Date: 23 May 2022
Our ref: 3237/22/5
Your ref: ABP - 313361

Re: SHD planning application for the construction of a total of 415 No. residential units (252 No. houses, 135 No. apartments, and 28 No. duplex units); with 1 No. childcare facility and ancillary residential amenity facilities, a proposed Strategic Housing Development, on lands at Back Road & Kinsealy Lane, Kinsealy, Broomfield, Malahide, Co. Dublin.

Photo 1 - Derailment in Co. Wicklow caused by third party works at the crest of a cutting.

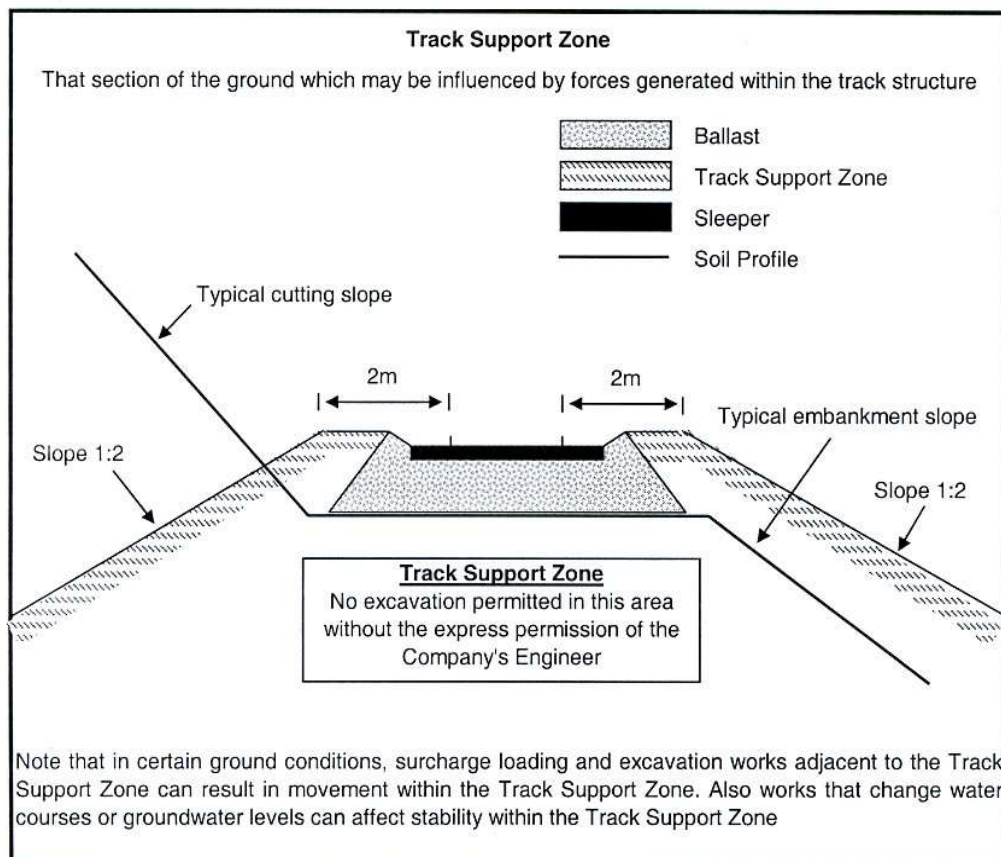
- 6) The integrity and functionality of any historical drainage channel running parallel to the railway at the crest of the cutting must not be affected by any temporary or permanent works or landscaping. Iarnród Éireann have had serious instances of slope failure in the past due to third party works at the crest of cuttings. Photo 1. below shows an example of a derailment in Co. Wicklow caused by third party works at the crest of a cutting.
